REFERENCE	BT_2014_FR16_3_UK
DATE	04 July 2014
SUBJECT	Engine cover fitting points repair, damper displacement sensor and beacon receiver mounting details and cooling system blanking
PART	Engine cover, damper displacement sensor, beacon receiver, sidepod

- Front suspension

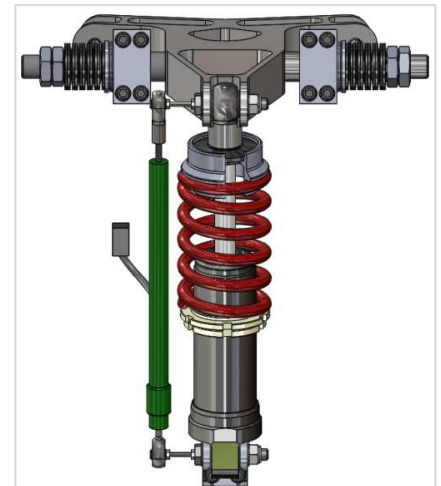
To mount the damper displacement sensor on the front rocker, replace the CHC M8 x 45 by the part "**G04-17D017V1 Machined Screw for Damper Displacement Sensor**". Use the nuts H M3 to tight the FHC M3 x 45 on the "**G04-17D017V1 Machined Screw for Damper Displacement Sensor**" and to avoid any contact between the sensor and the damper.

- Rear suspension

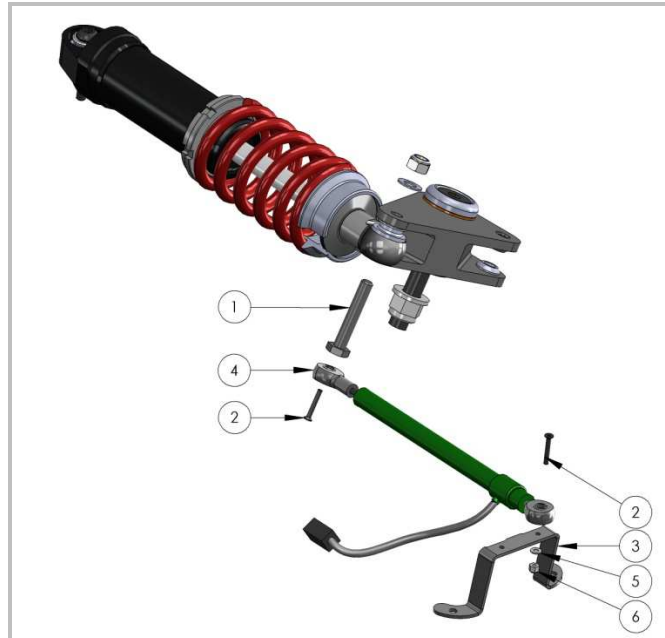
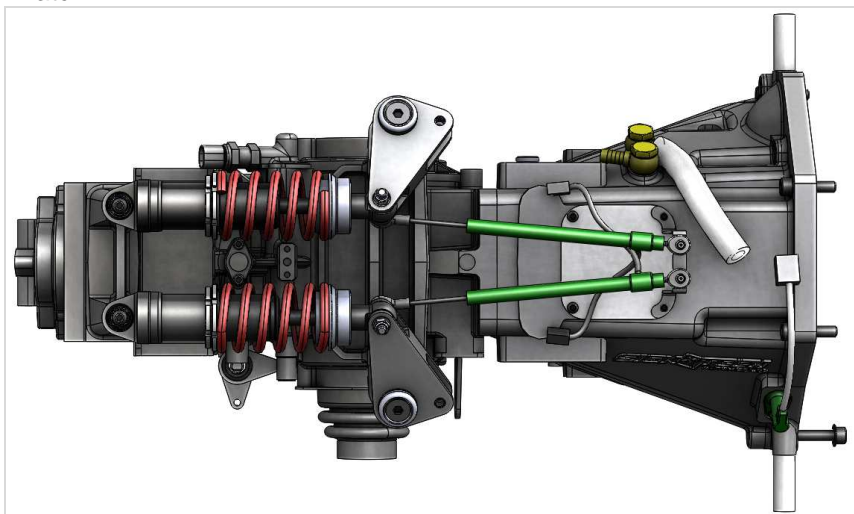
To mount the damper displacement sensor on the rear rocker, replace the CHC M8 x 45 by the part "**G04-17D017V1 Machined Screw for Damper Displacement Sensor**". Place the part "**G04-16D013V1 Damper Displacement Sensor Support**" on the bell housing: use the two threaded holes (the closest to the back of the tub) used to mount the Catch Tank Hatch.

### 3 Beacon receiver mounting details

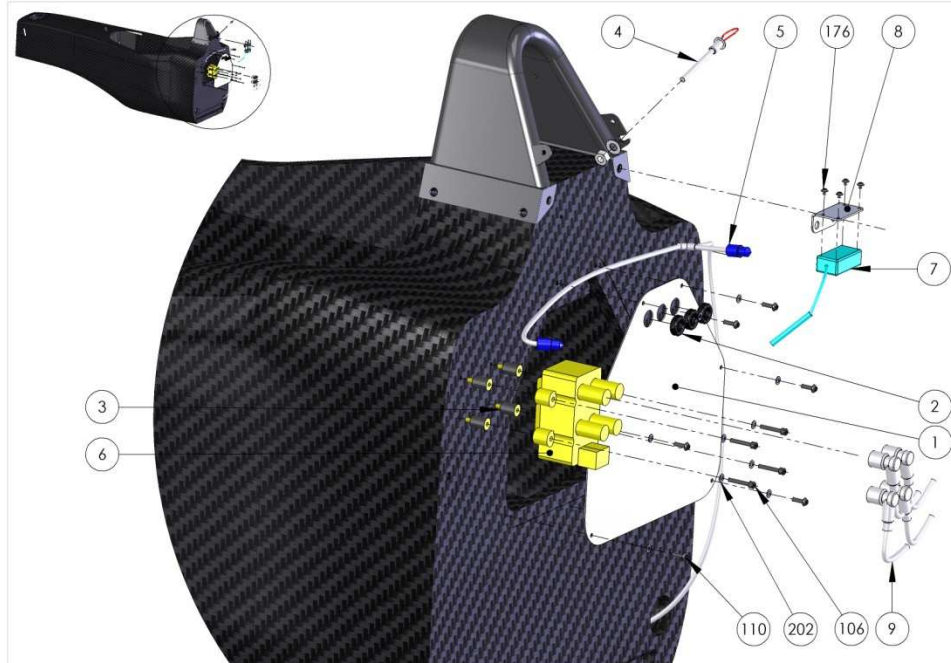
There is only one possible fitting position for the **G04-05B007V2 Beacon Receiver** (Rep. 7) in the car. It must be mounted on the part **G04-05B008V2 Beacon Bracket** (Rep.8) on the tub's back as shown in the picture.

It can be mounted on the right side or left side of the roll hoop depending of the position of the track beacon cell with the same part (reversible part).

*If the old version of the Beacon receiver (**G04-05B007V1 Beacon Receiver**) is used, you must only mount it on the **G04-05B008V1 Beacon Bracket**.*

#### 4 Cooling system blanking

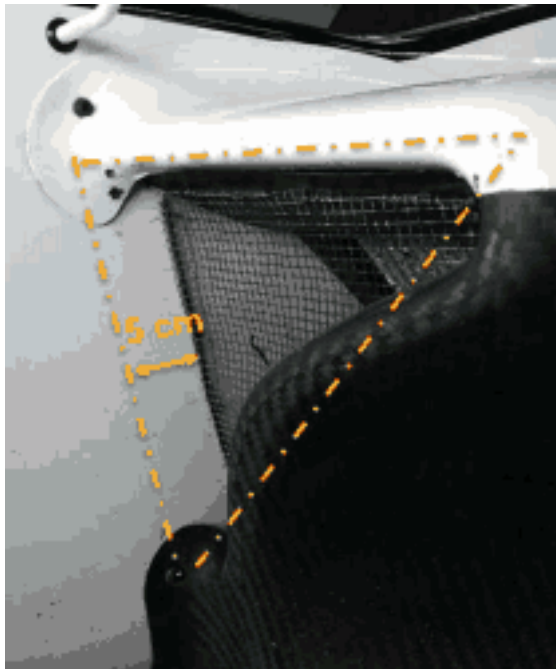
Only blanking directly applied on the water radiator or on the water radiator nets are allowed. Any other blanking regarding the cooling system is forbidden (Tape directly applied on the sidepod bodywork is forbidden)

- Radiator nets must be fitted inside the sidepod. Nets location is ruled between 5cm and 10cm behind the sidepod inlet section as shown in the picture below
